**SUNDRY NOTICES AND REPORTS ON WELLS**  
*Do not use this form for proposals to drill or to re-enter an abandoned well. Use Form 3160-3 (APD) for such proposals.*

Pecos Federal # 2

**Permanent Abandonment of Federal Wells**  
**Conditions of Approval**

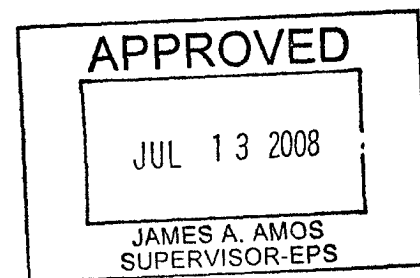
X 6. RIH w/ tbg. to 2950. Spot 45 sx plug 2950 to 2800. 2670' WOC Tag

X 7. Spot 35 sx plug @ 410-300. 550'-315'. WOC Tag

X 8. Spot 10 sx plug @ 30 to surface. 60' - surface
